H. B. ROBINSON STEAM ELECTRIC PLANT, UNIT NO. 2
DOCKET NO. 50-261/LICENSE NO DPR-23

SUPPLEMENTAL INFORMATION REGARDING
NRC BULLETIN 2001-01, "CIRCUMFERENTIAL CRACKING OF
REACTOR PRESSURE VESSEL HEAD PENETRATION NOZZLES"

RESPONSES TO REQUESTS FOR ADDITIONAL INFORMATION
REGARDING NRC BULLETIN 2001-01, "CIRCUMFERENTIAL
CRACKING OF REACTOR PRESSURE VESSEL HEAD PENETRATION NOZZLES"

Figure B-1

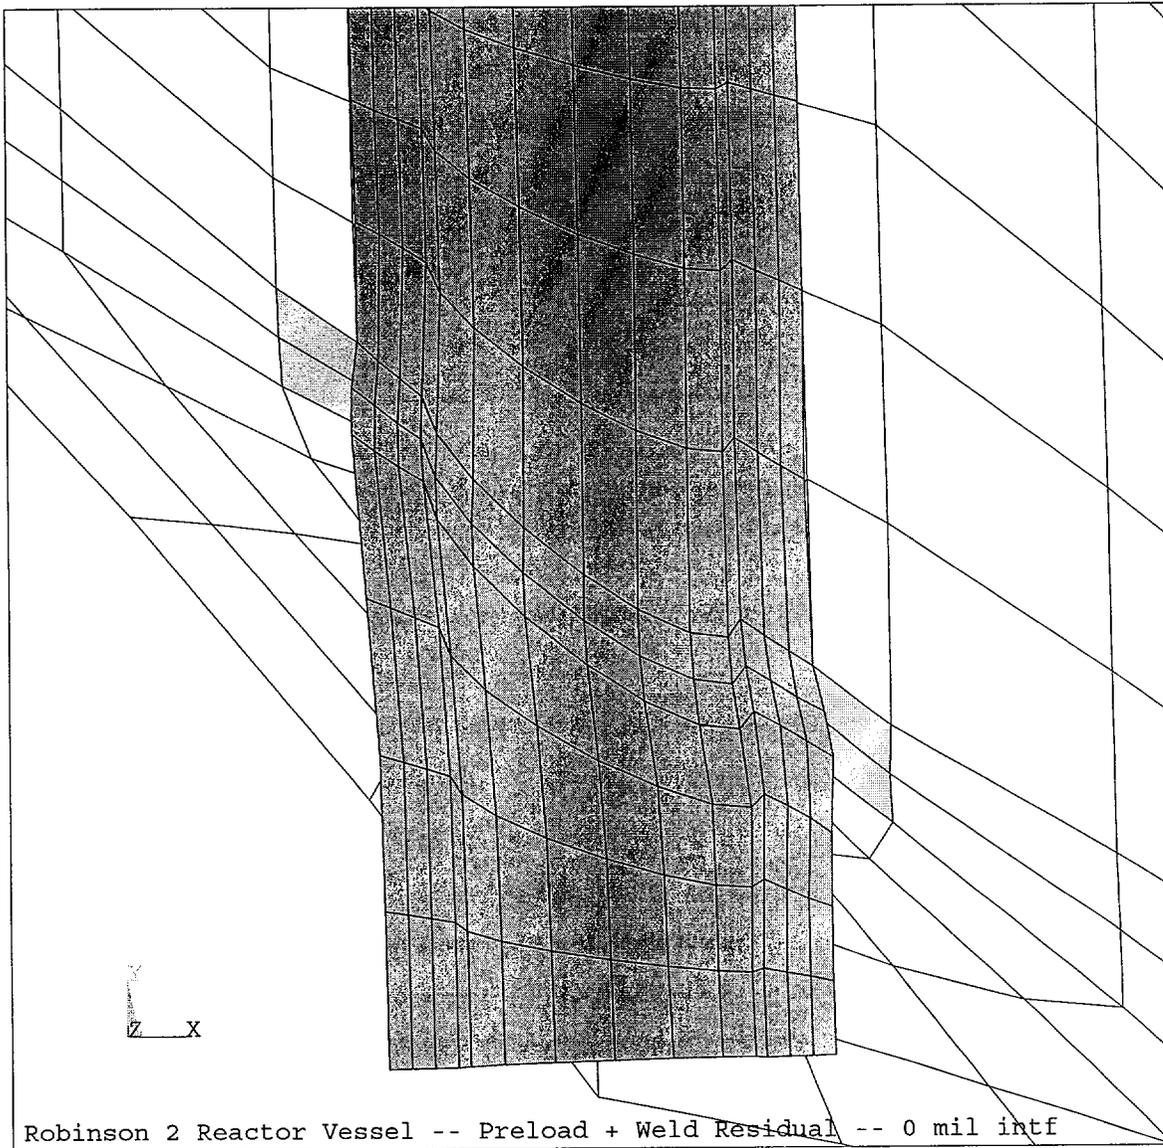
- Figure B-1 shows deflections of Nozzle #11 after imposing the constraint equations simulating the J-groove weld distortion for the case with no initial interference fit. This figure shows the nozzle wall being pulled outward at the weld and being bent around the buttering region thereby creating a small annular pocket above the weld. This figure also shows the laterally outward deflection of the bottom of the nozzle as was reported in EPRI TR-103696, *PWSCC of Alloy 600 Materials in PWR Primary System Penetrations*. (See Figure A-9)

Figure B-2

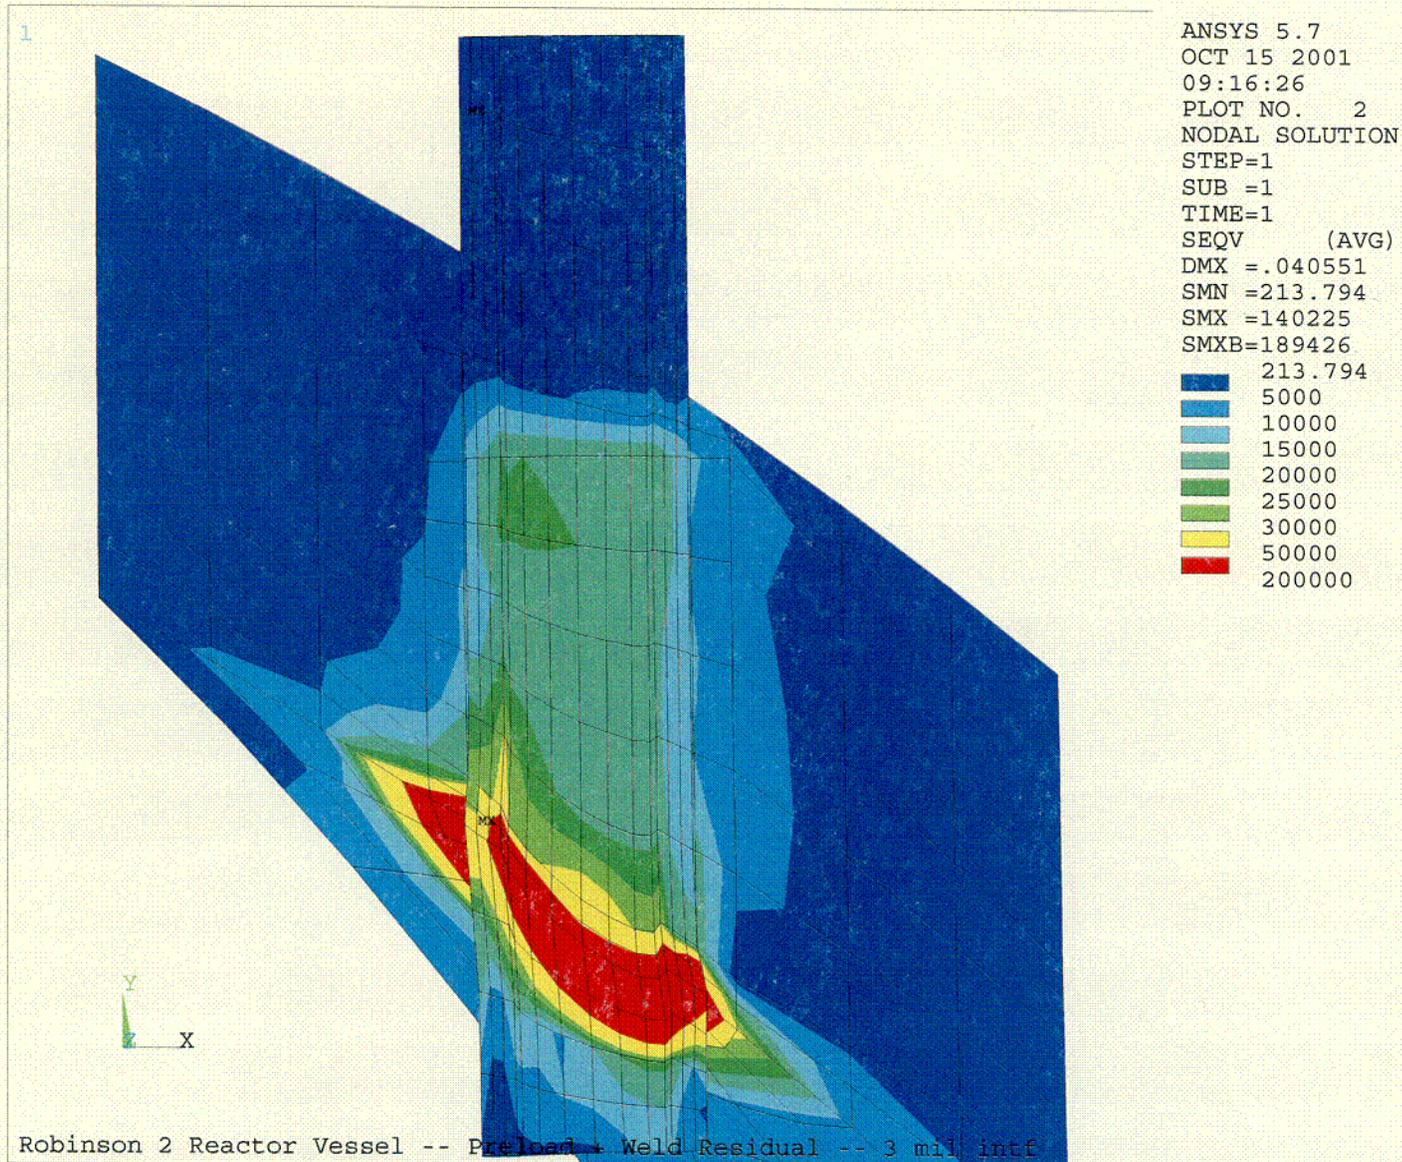
- Figure B-2 is identical to Figure B-1 except that it is for the case with a 0.003" initial interference fit. This figure shows the nozzle wall being pinched inward at the upper counterbore region, and the resultant compressive stresses in the nozzle in the interference fit region.
